REMARKS

In the non-final office action mailed February 27, 2006, claims 1-44 were pending and stand rejected. Claim 2 has been cancelled in this response, and claims 1, 9, 14, 15, 17, 28, 35, 37 and 40 have been amended. Reconsideration of the present application including claims 1 and 3-44 as amended is respectfully requested.

Fig. 4

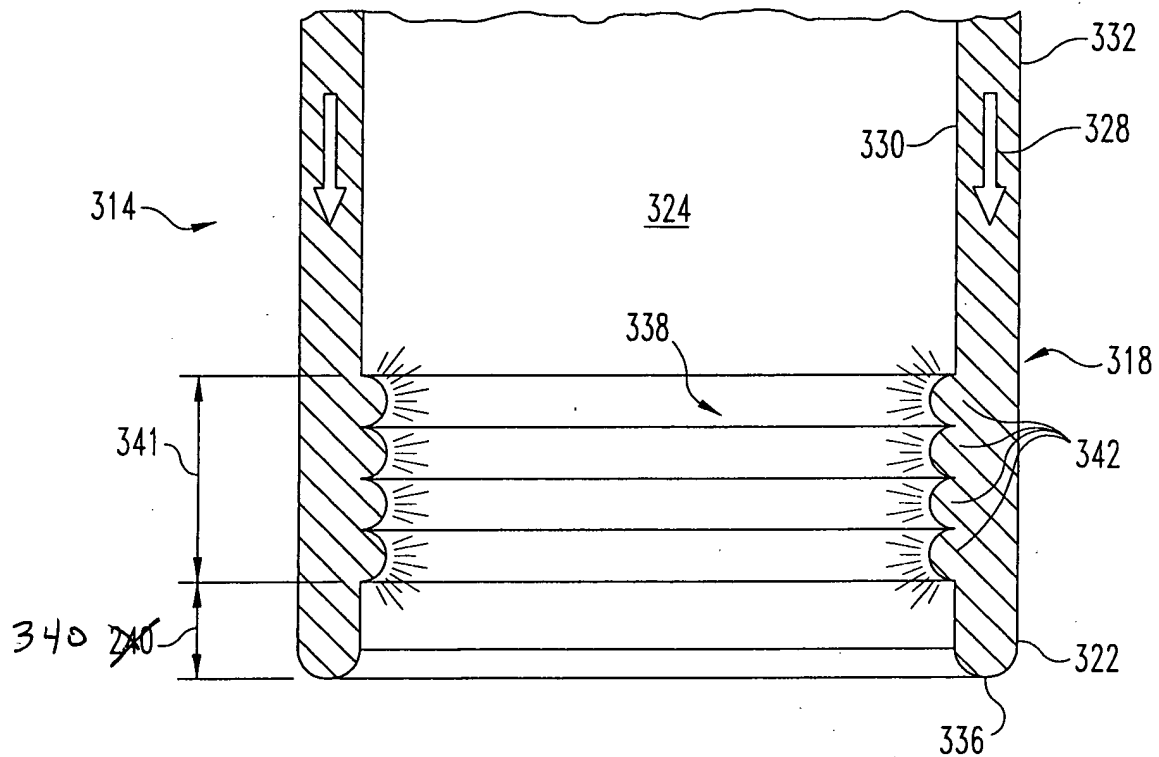
The drawings were also objected to for not including reference signs 340 and 628 therein. Please find enclosed herewith two sheets labeled "REPLACEMENT SHEET" to replace corresponding sheets in the originally filed drawings. These replacement sheets include the reference signs 340 and 628 added to Figures 4 and 7, respectively, in a manner consistent with the specification. Also enclosed are two sheets labeled "ANNOTATED SHEET" to show the proposed changes Figures 4 and 7 marked in ink. Withdrawal of the objection to the drawings is respectfully requested.
